PROPOSED S4.56 MODIFICATIONS LIST:

S4.56 MODIFICATIONS

9-11 VICTORIA PARADE, MANLY, NSW

DRAWING TITLE  
FIRST BASEMENT PLAN

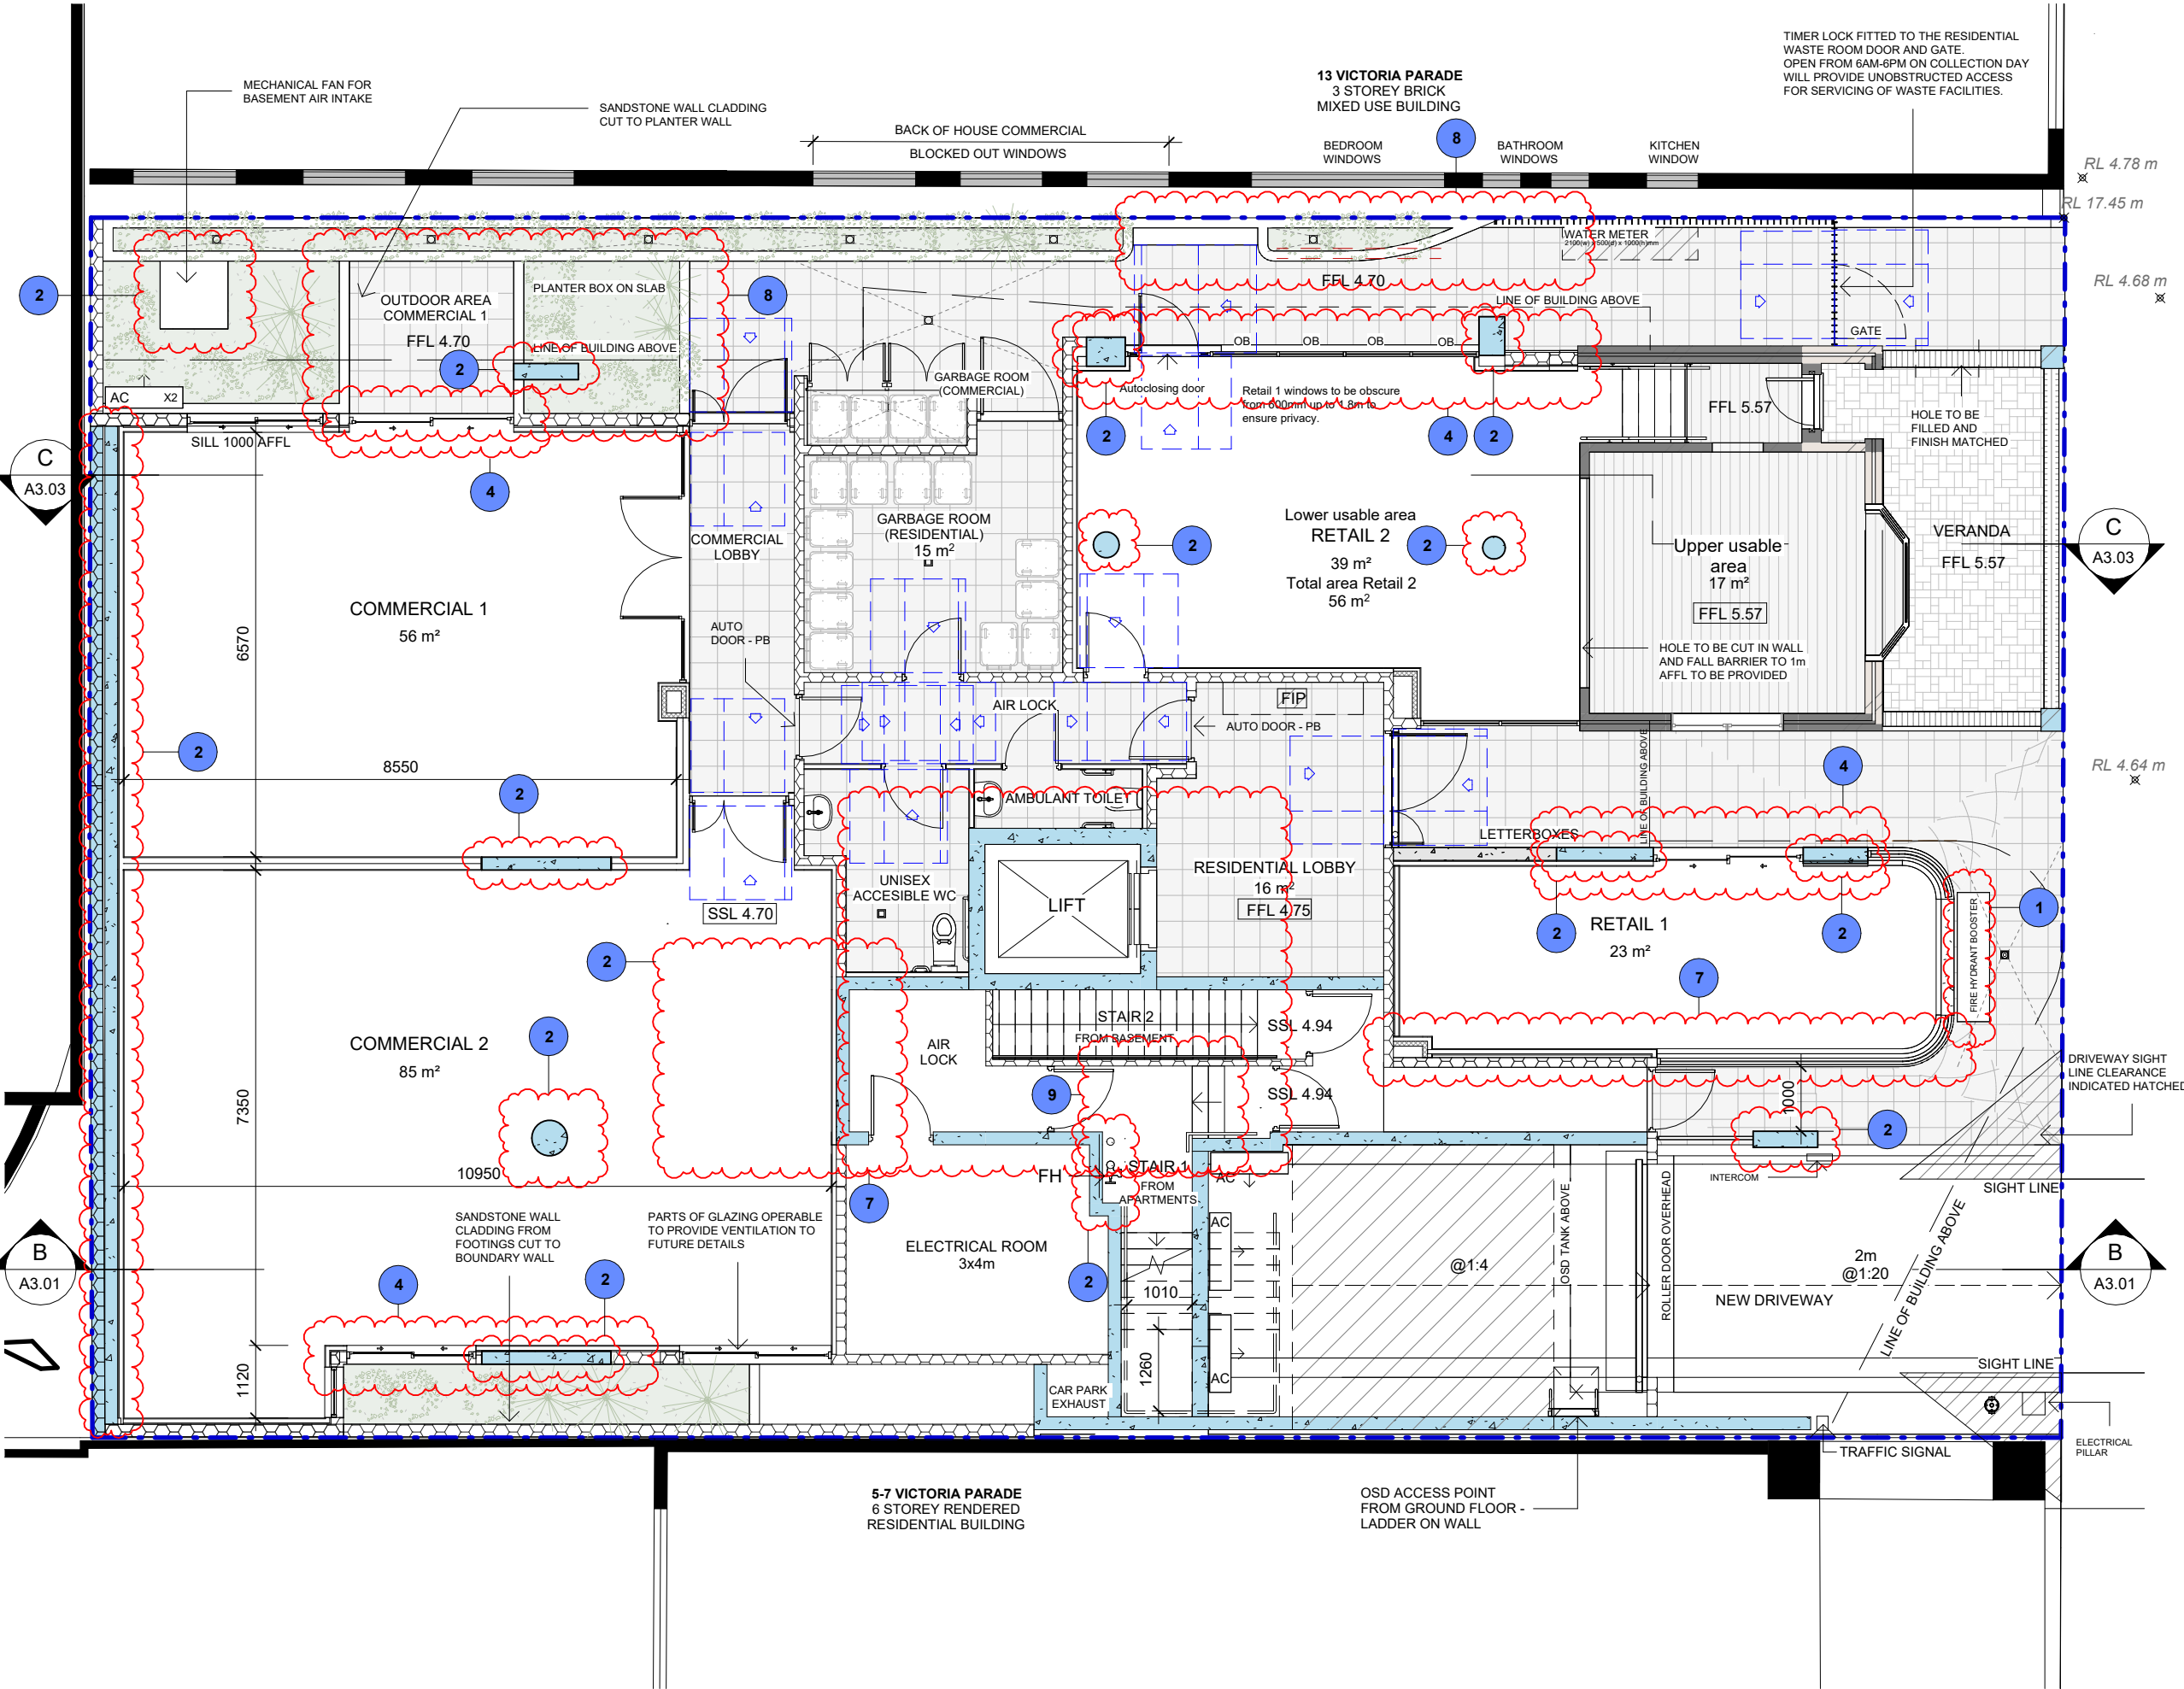
1. Revised fire hydrant booster location
2. Revised internal layouts and associated services and structure.
3. Amalgamation of Units 10 & 11 on Level 4 to a single SOU.
4. Revised window size and location in response to revised layouts.
5. BBQ added to terraces
6. Skylights added
7. Revised Core position and related walls
8. Revised landscaping area
9. Revised fire stairs
10. Revised storage cages
11. Added HWP and moved AC units
12. Addition of blade wall
13. Addition of Photovoltaic Panels
14. Proposed enclosure of parking spaces into private garages.

SOUTHEAST ELEVATION

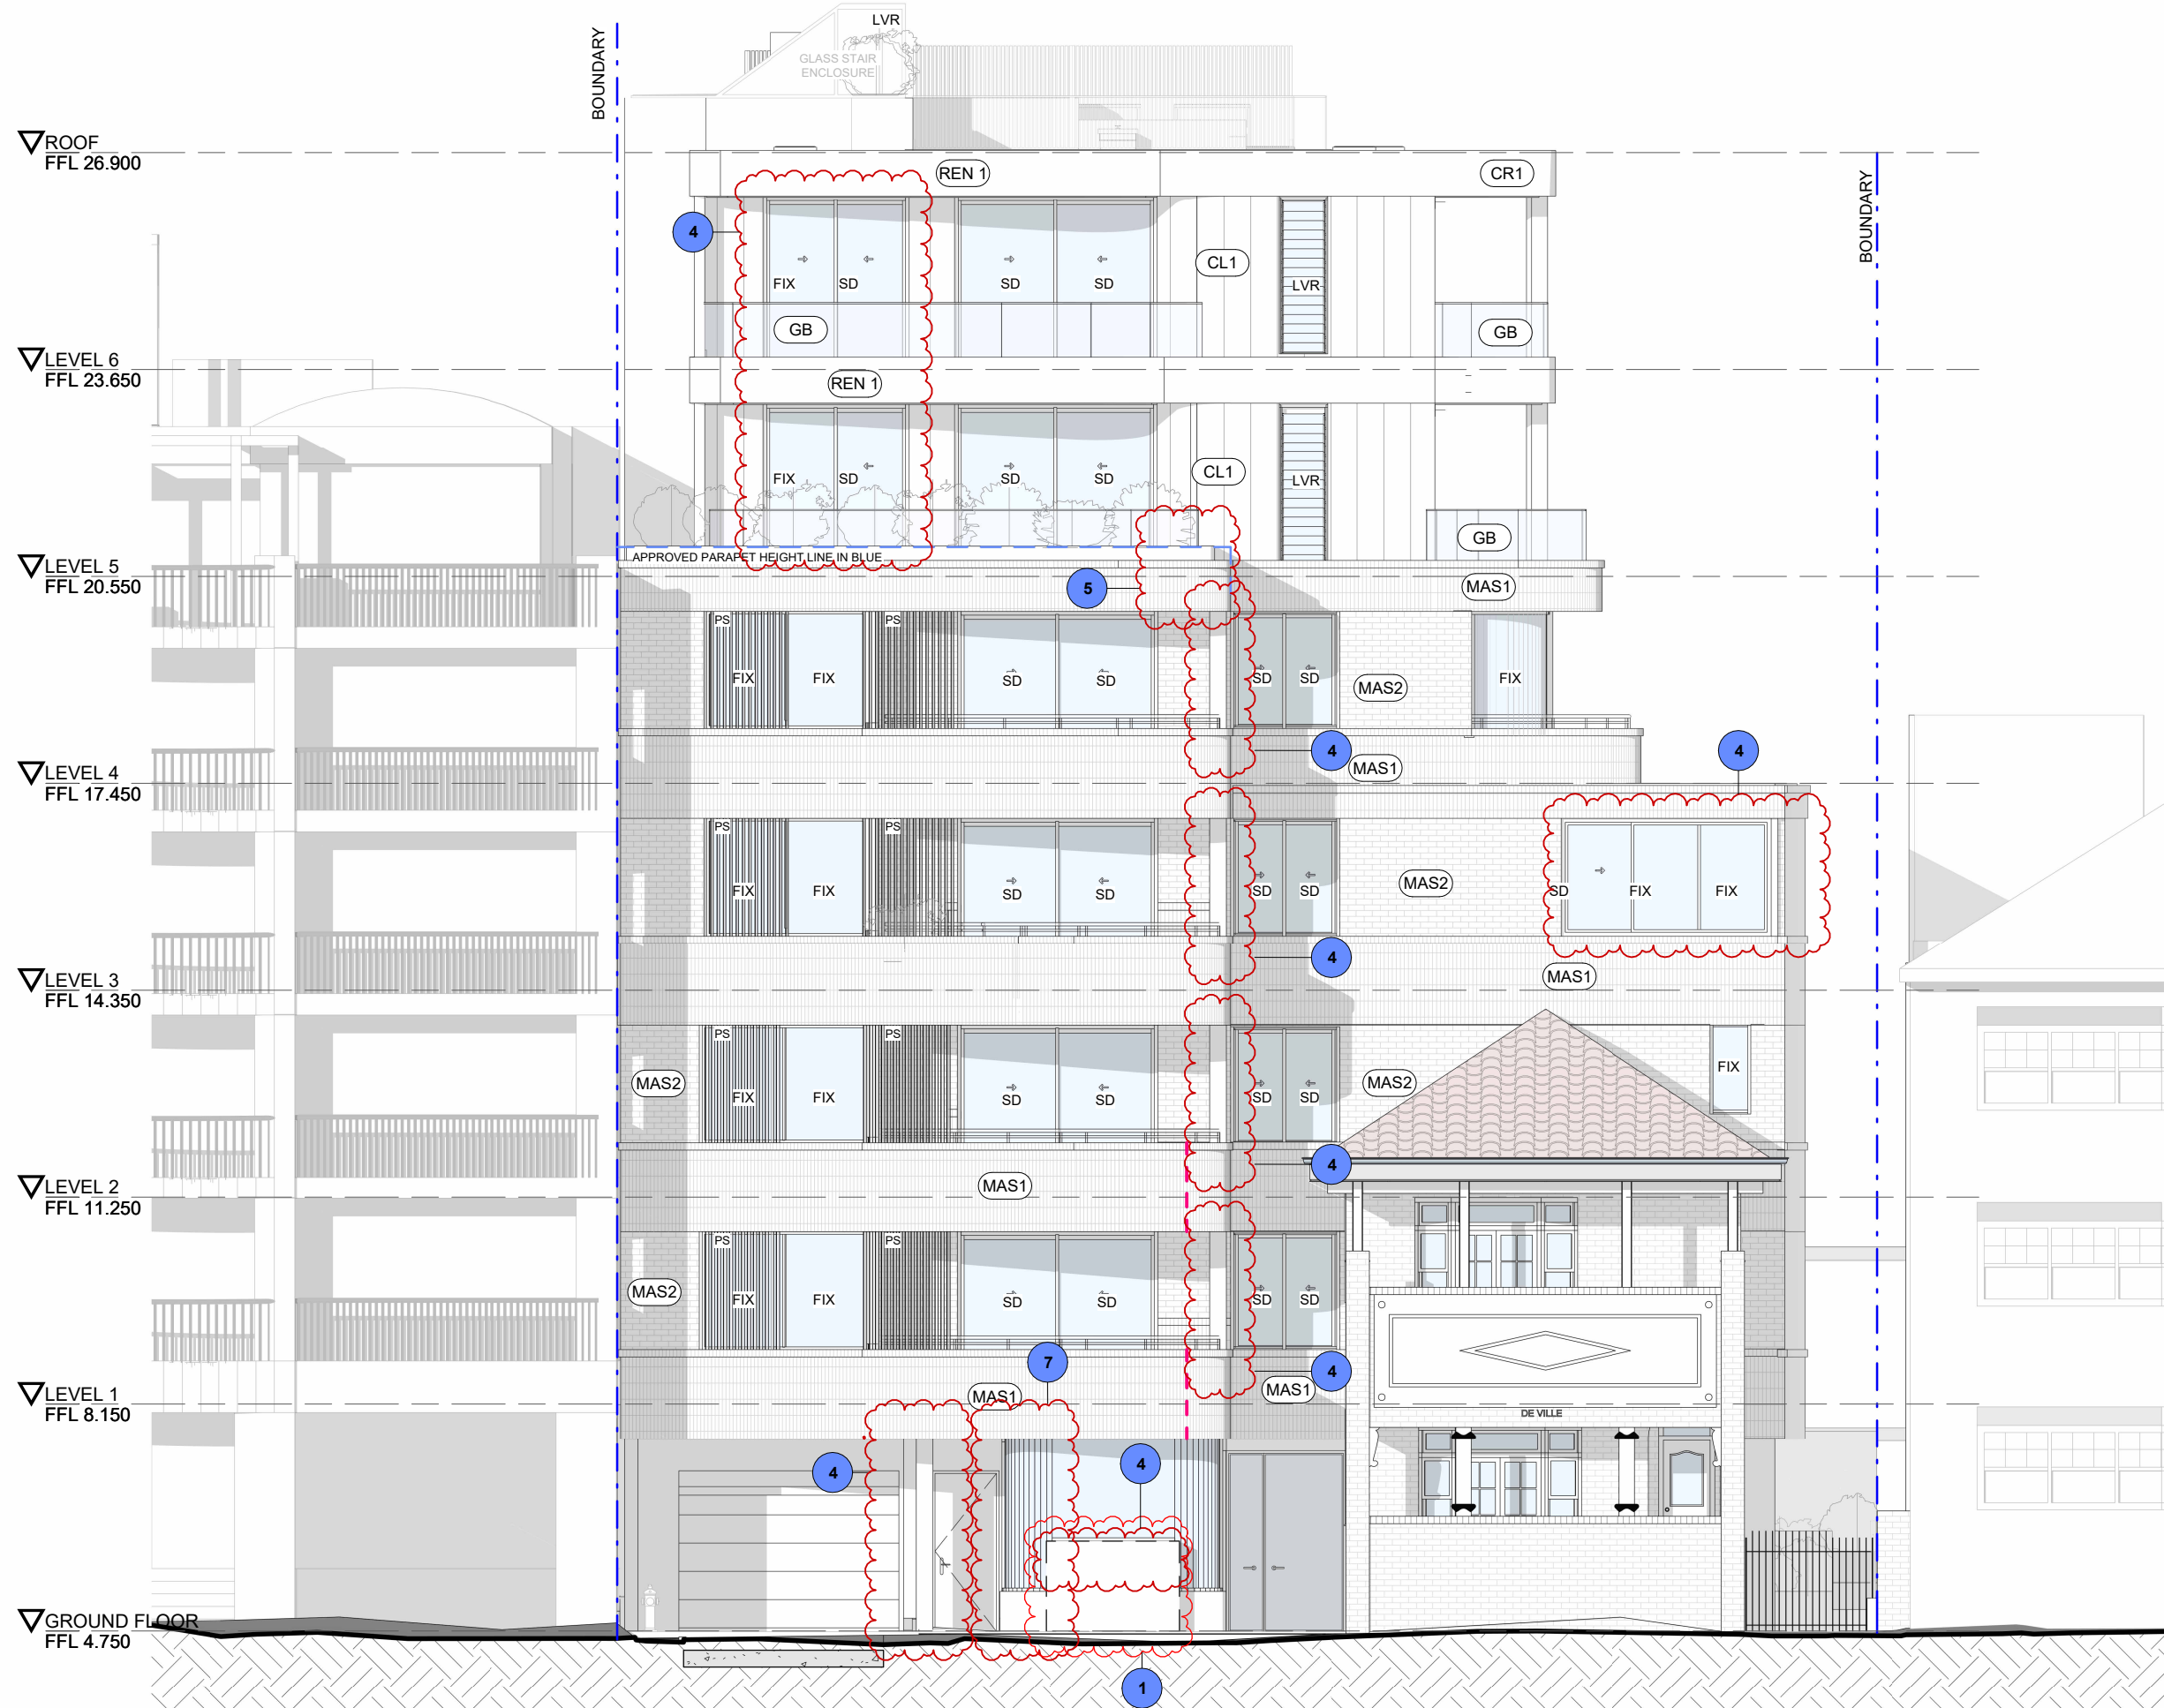
1. Revised fire hydrant booster location
2. Revised internal layouts and associated services and structure.
3. Amalgamation of Units 10 & 11 on Level 4 to a single SOU.
4. Revised window size and location in response to revised layouts.
5. BBQ added to terraces
6. Skylights added
7. Revised Core position and related walls
8. Revised landscaping area
9. Revised fire stairs
10. Revised storage cages
11. Added HWP and moved AC units
12. Addition of blade wall
13. Addition of Photovoltaic Panels
14. Proposed enclosure of parking spaces into private garages.
